Our Ref: 2323_TPA42

27 July 2026

Approval Ref: A006847313

Subject: Traffic Statement - Minor Change to Approval

Drawing / LOWER GROUND 06

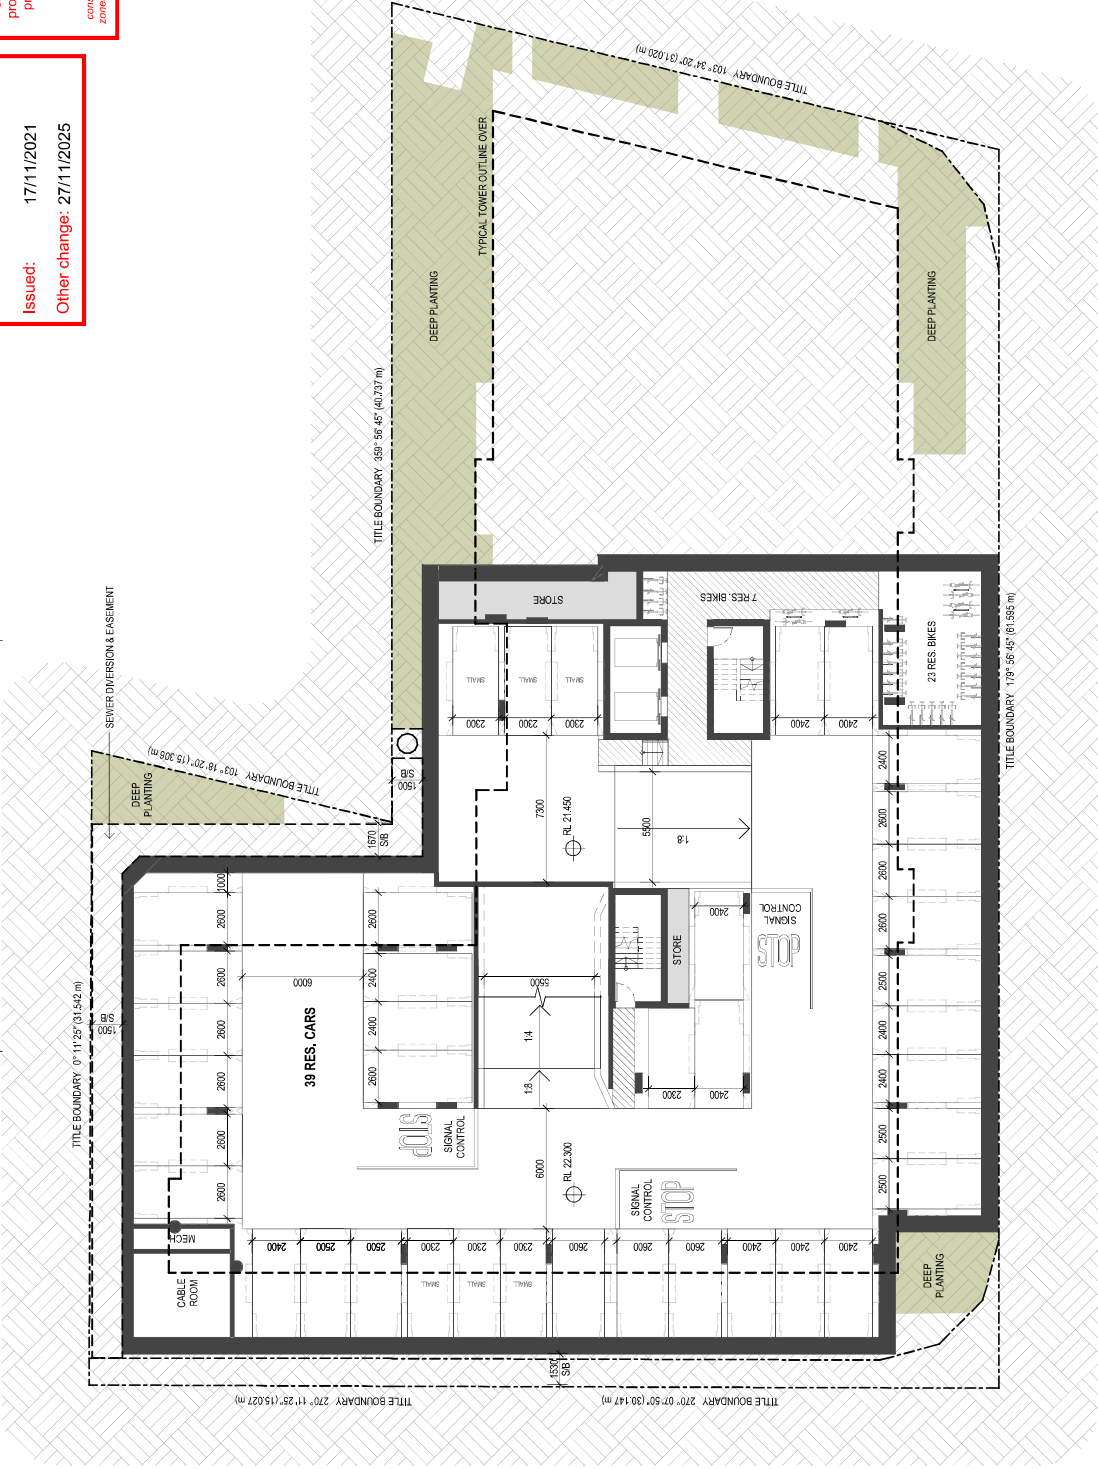
- a 5.85m parking aisle on Lower Ground 05 and Lower Ground 06 in lieu of the generally approved 6.0m aisle;
- one 2.3m wide bay on Lower Ground 04 identified as a small-car space;

- retention of the approved parking numbers on each level: 39 resident spaces on Lower Ground 06, 39 resident spaces on Lower Ground 05, and 20 resident plus 11 visitor spaces on Lower Ground 04;

Plans of Amended Development Scheme

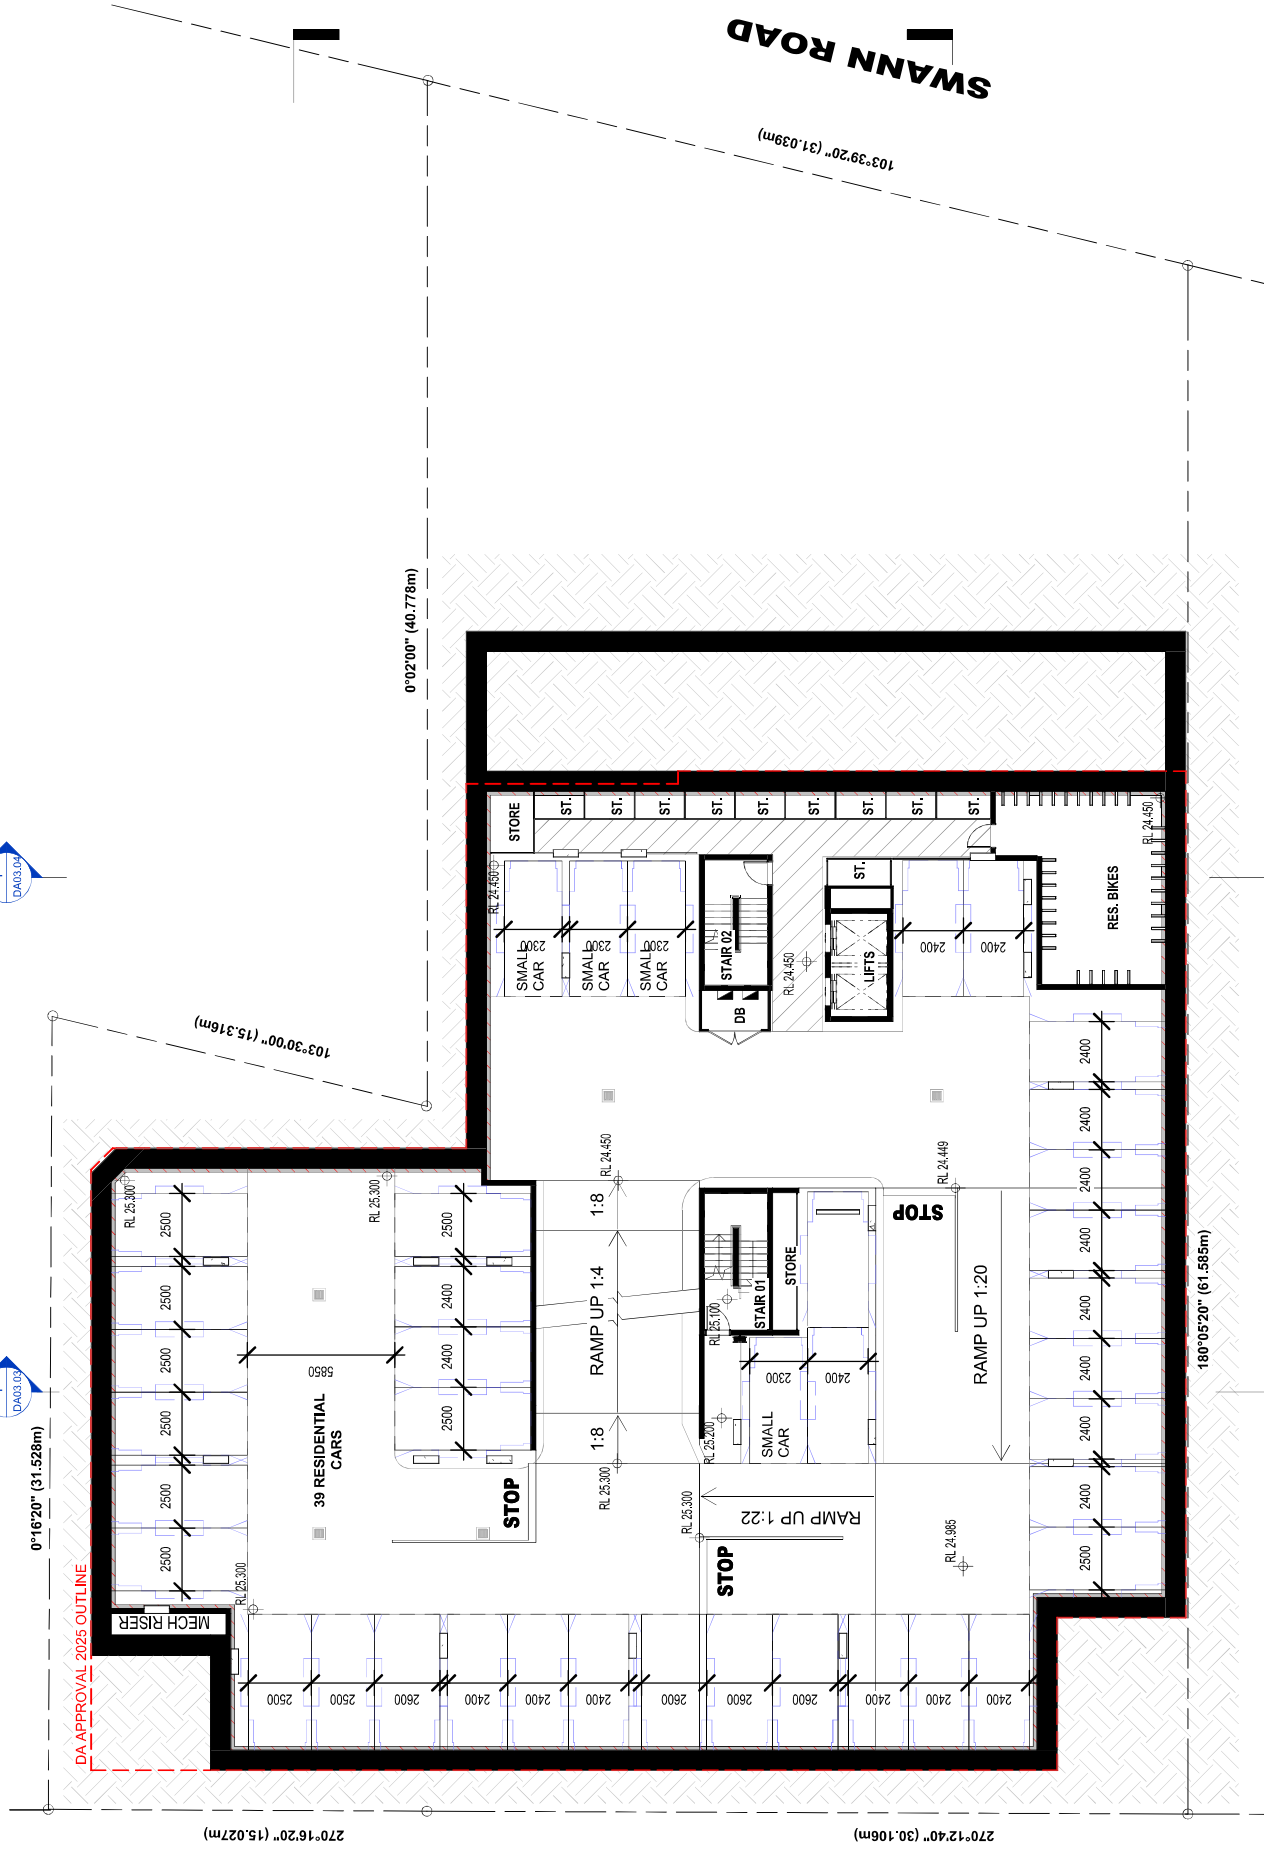
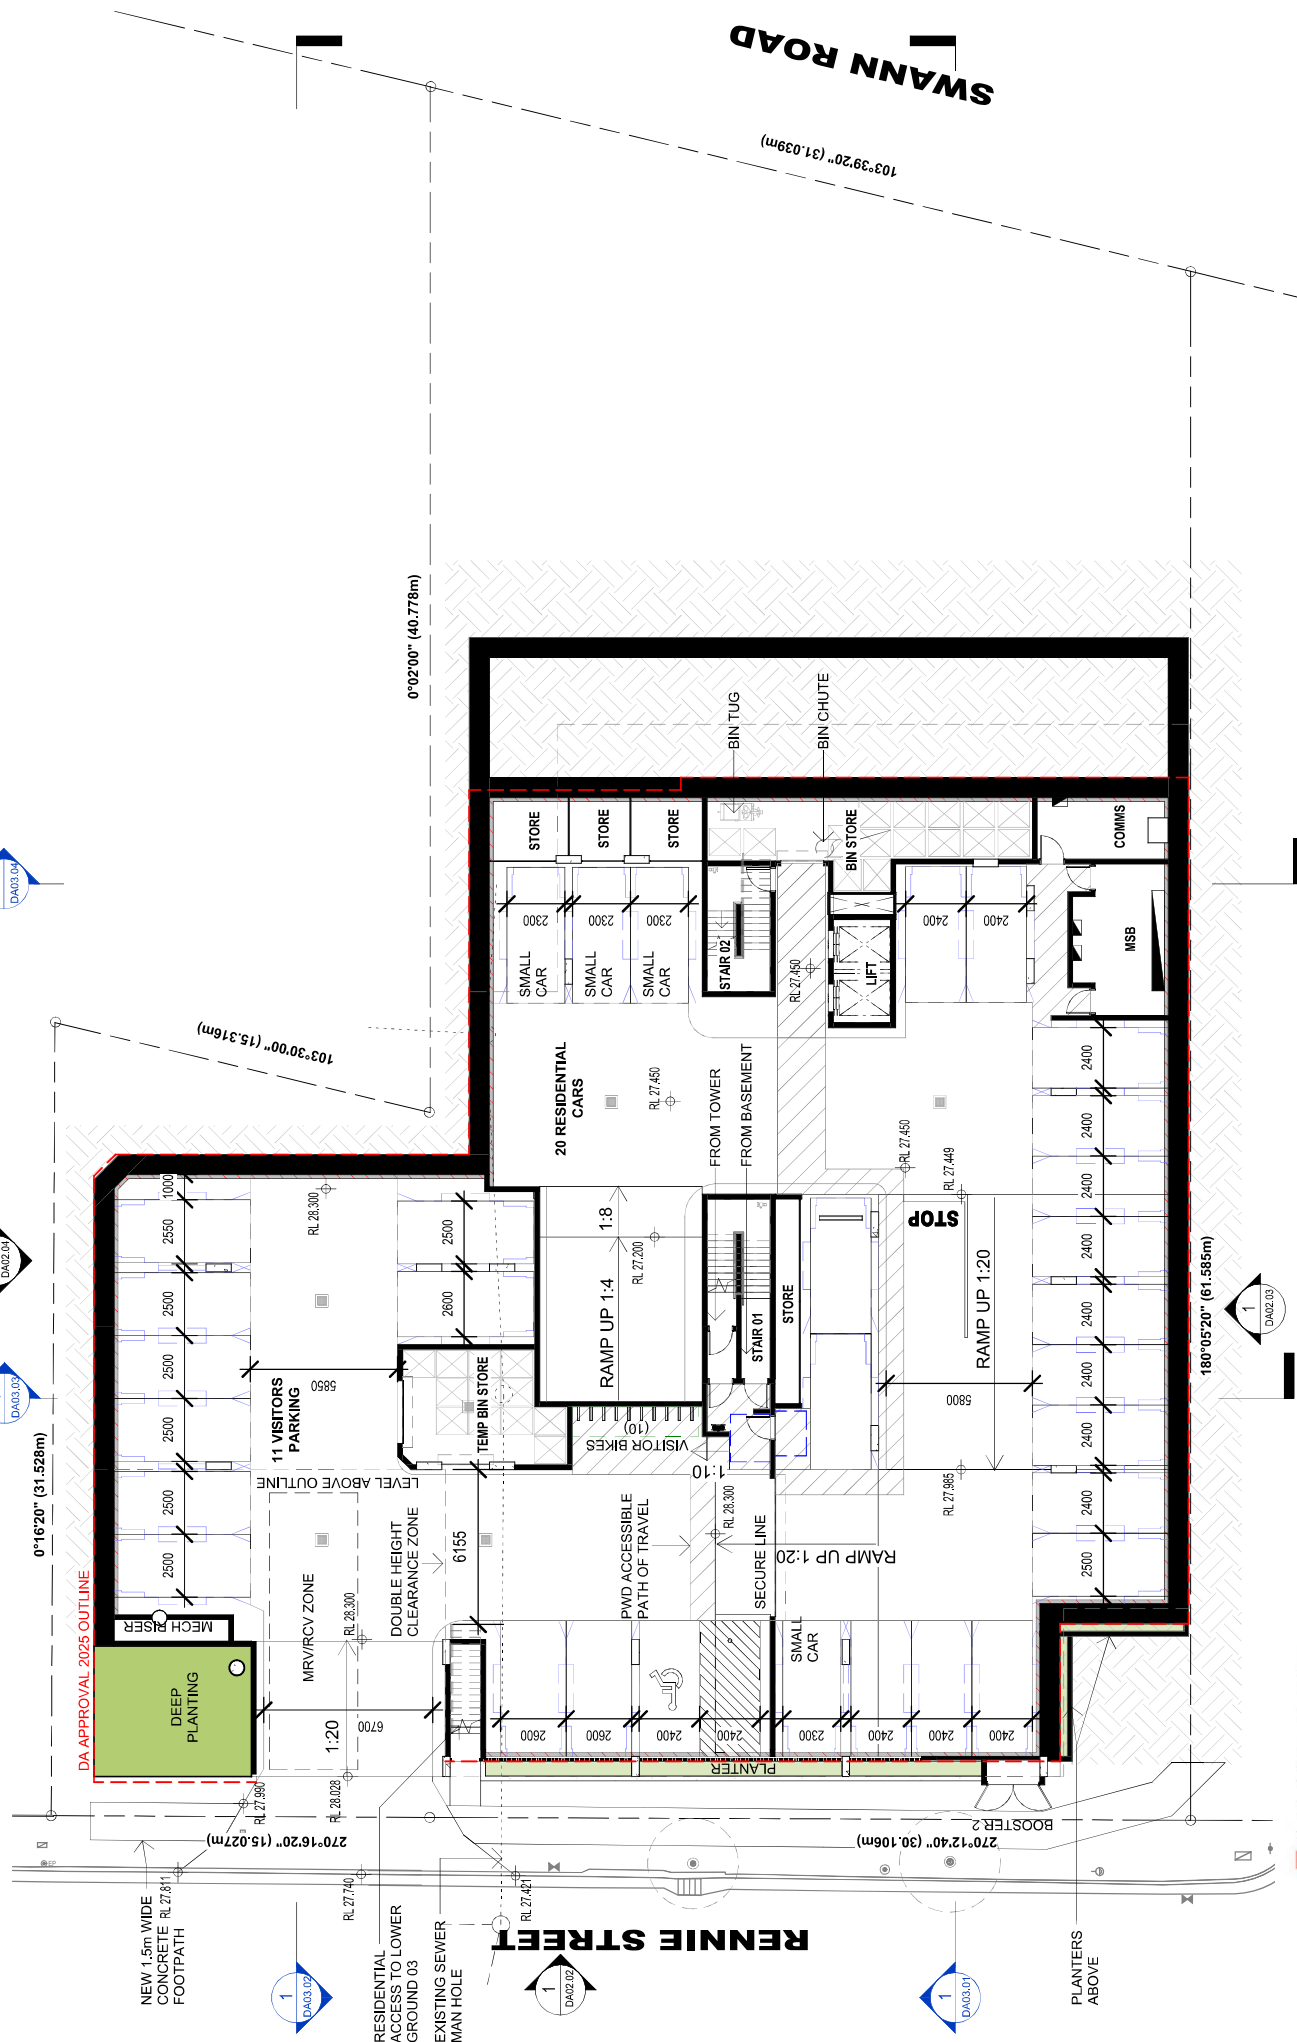
The parking and servicing changes identified on the amended Lower Ground 04, 05 and 06 plans are:

- adjustments to individual resident bay widths, generally from 2.5m or 2.6m to 2.4m or 2.5m, due to revised columns, walls and lift/stair cores;
- an increase in several previously approved 2.3m bays to 2.4m;

- retention of the internal signal-control system and the same STOP/hold-line locations shown in the approved traffic drawings;
- minor internal reconfiguration of the bin rooms, services and building cores while retaining the MRV/RCV standing zone and collection interface; and

- relocation of the pad-mounted transformer and hydrant booster from Rennie Street to the Swann Road frontage.

- the minimum standard resident bay width remains 2.4m, consistent with the minimum accepted under the approved traffic statement;

- the identified 2.3m bays are designated as small-car spaces and remain well below 20% of the resident parking supply;
- the 5.85m aisle is greater than the 5.8m aisle already accepted at one location under the approved arrangement and satisfies the AS 2890.1 User Class 1A dimensional combination for 2.4m wide resident bays;
- the ramps, circulation aisles and vehicle control system remain in the approved locations; and
- the STOP/hold lines have been added to the architectural change plans in the same locations as the approved swept-path drawings.

Parking allocation should be managed so that any apartment provided with only one resident parking space is allocated a bay with a minimum clear width of 2.6m. Bays less than 2.6m wide should be allocated as part of a two-space entitlement or otherwise designated for small-car use, consistent with Council's prelodgement advice.
